KP412/ BB Cable Guide

About this Service Bulletin

Figure A.

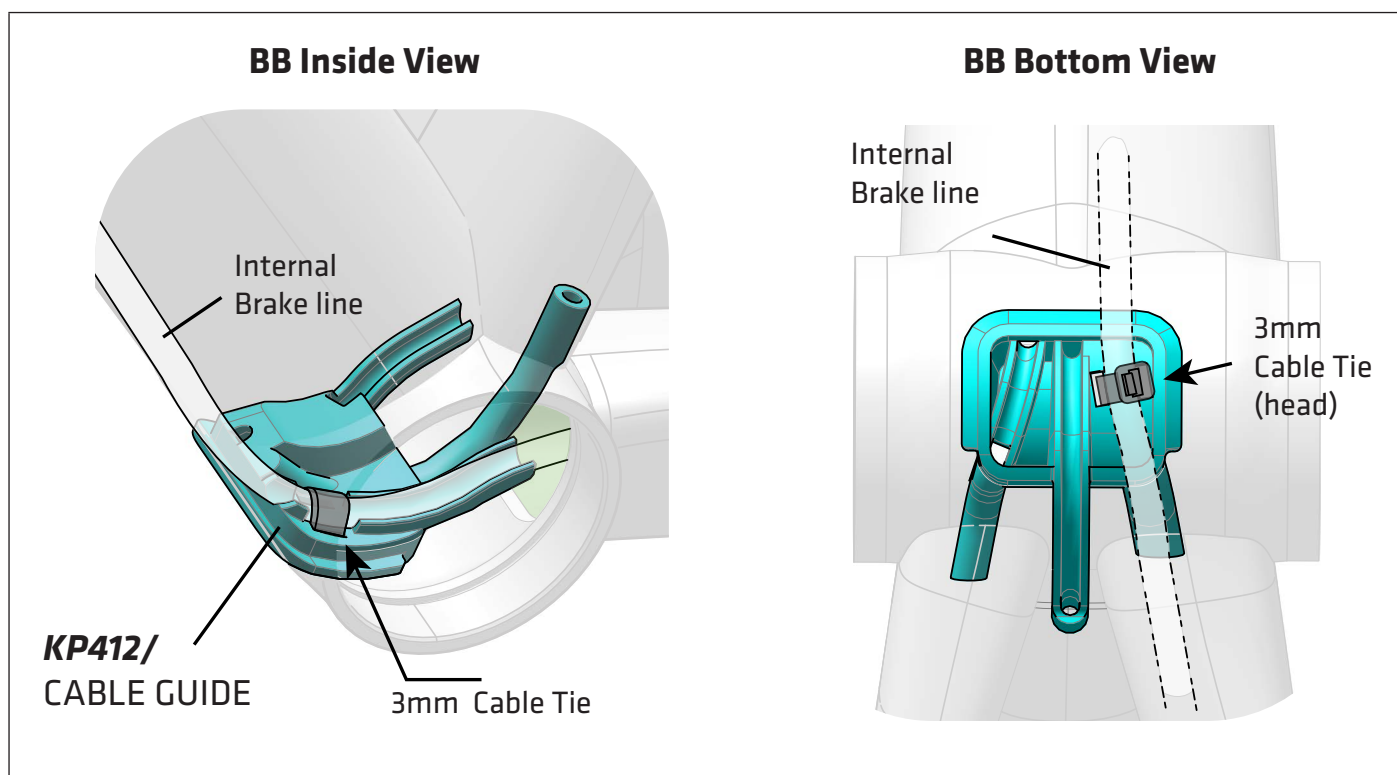
Secure the brake line to the **KP412/** cable guide using a 3mm cable tie as shown in Figure A .

Secure the brake line to the KP412/ cable guide using a 3mm cable tie as shown in Figure A. The brake line must not rub the crank spindle. If the brake line rubs the crank spindle, it could cut the spindle and lead to a fall and possible injury.
